**RE: Technical Notice of Deficiency Email Dated June 30 – Tracking No. 28154406
MSW Permit No. 2417 – South Texas Dewatering Facility**

May 2, 2023 NOD Comments and Responses

SOUTH TEXAS DEWATERING FACILITY, ALICE, JIM WELLS COUNTY, TEXAS MSW PERMIT NO. 2417

TCEQ MSW Type V Permit Application

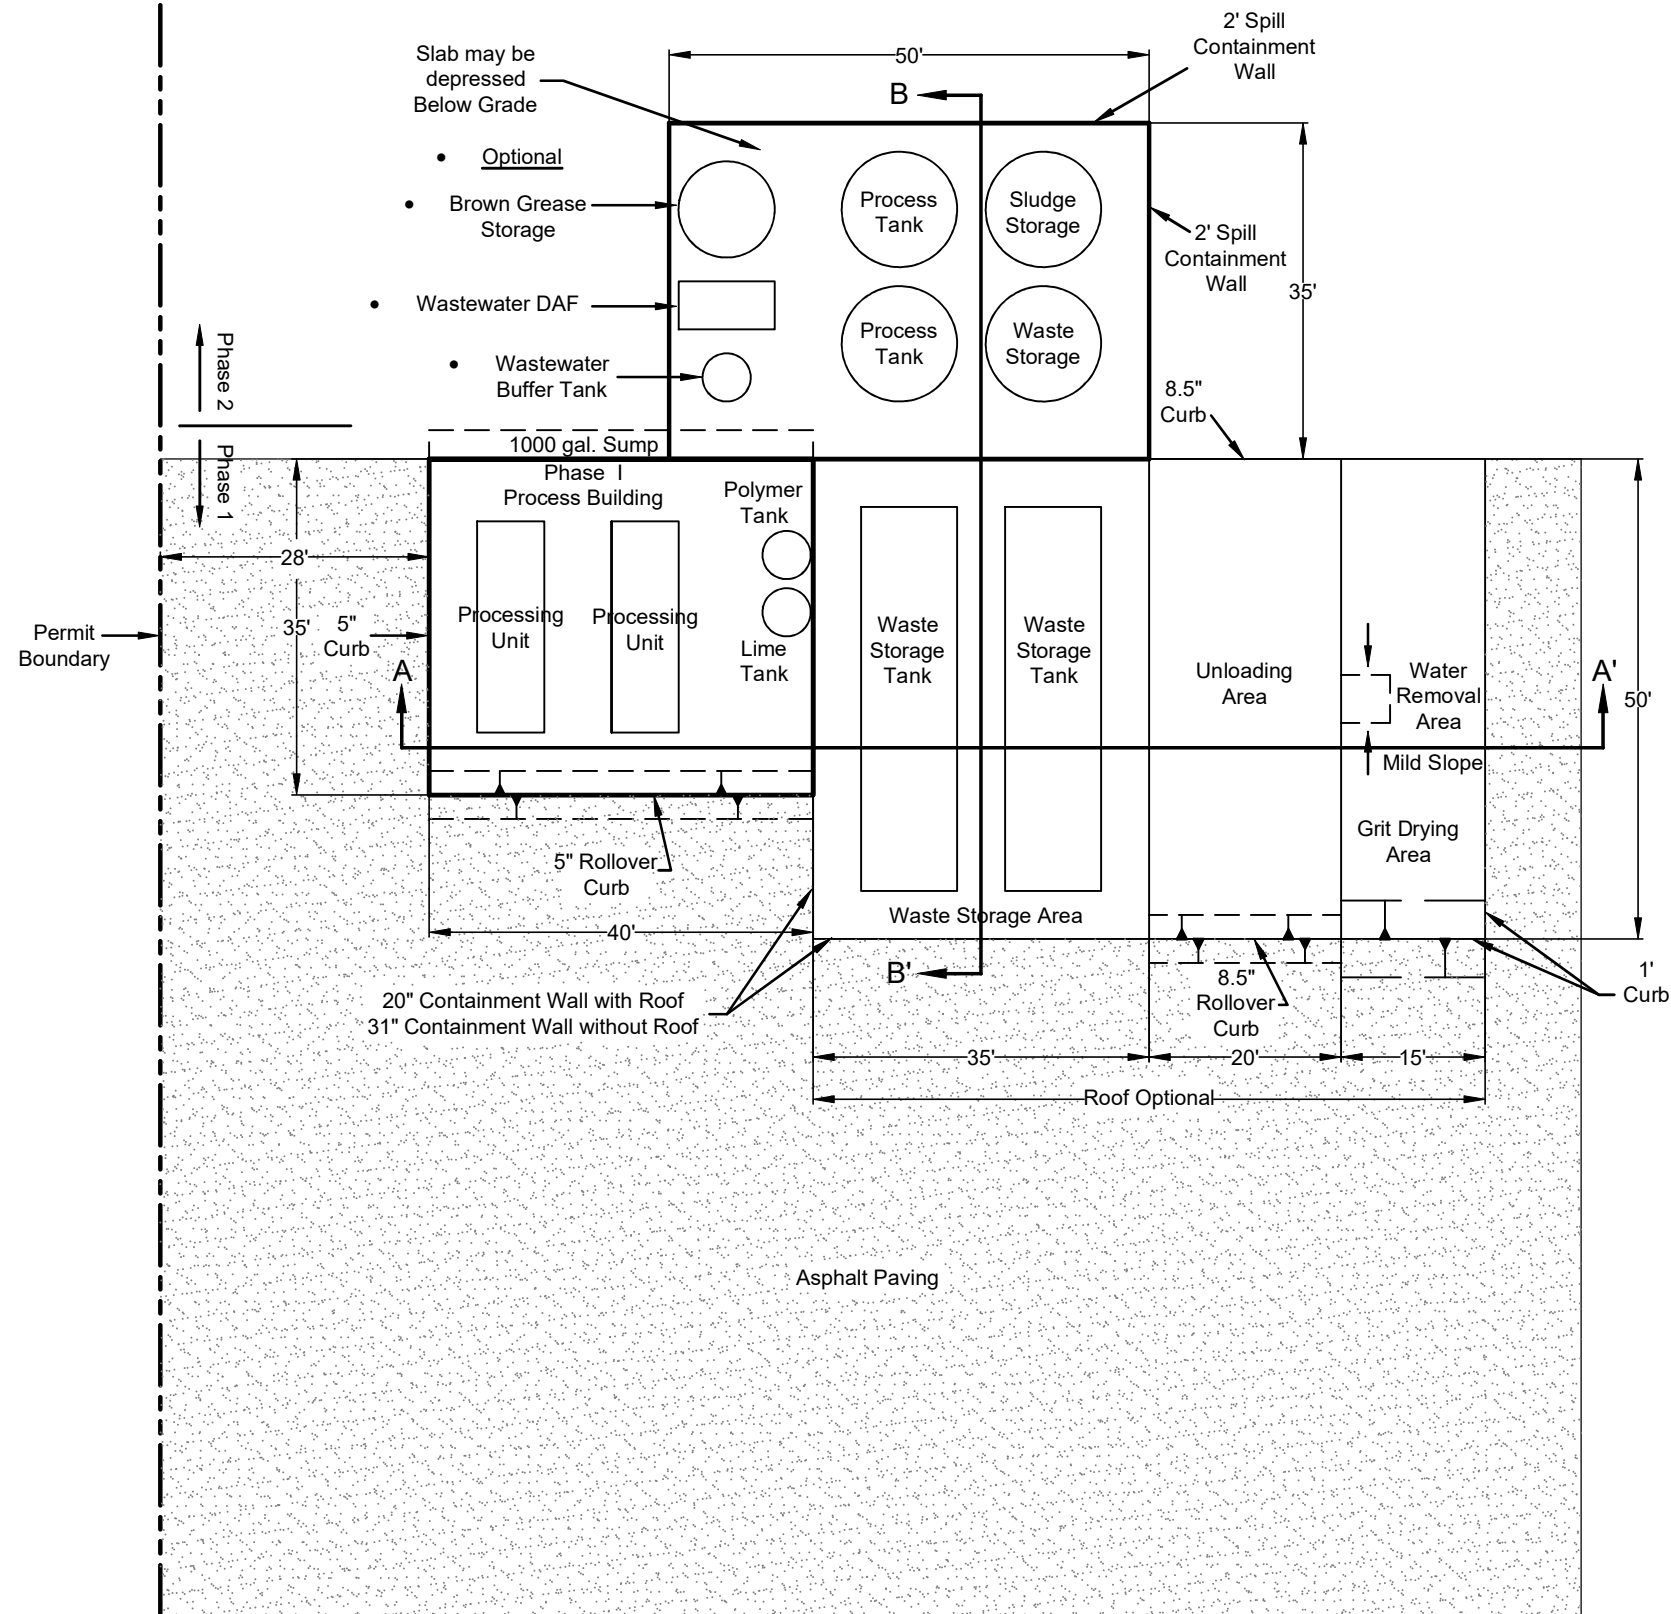
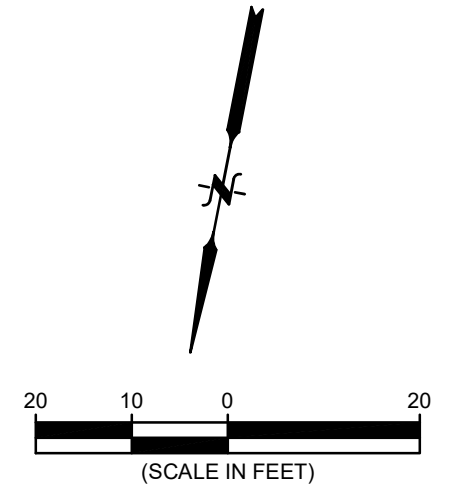
6. Figure 9 illustrates three sumps. Provide generalized construction details for each. If protective coatings and periodic inspections will not be provided, explain how secondary containment will be provided.

7. Provide a diagram showing the access routes and the expected flow of traffic within the facility. It appears from the current figure that traffic will pull directly in and back directly out. Explain if, and if so where, any turnaround will occur and how adequate turning radii are provided.

Response: The revised spill protection descriptions have removed sumps at the unloading slab and grit drying area. Section 3.3 states that sumps will have a geomembrane underliner or protective surface coating with periodic inspections.

Response: Figure 9 has been revised to show that truck traffic will enter the facility and will make a U-turn to back into the unloading area. Figure 9 shows that adequate turning radii are provided.
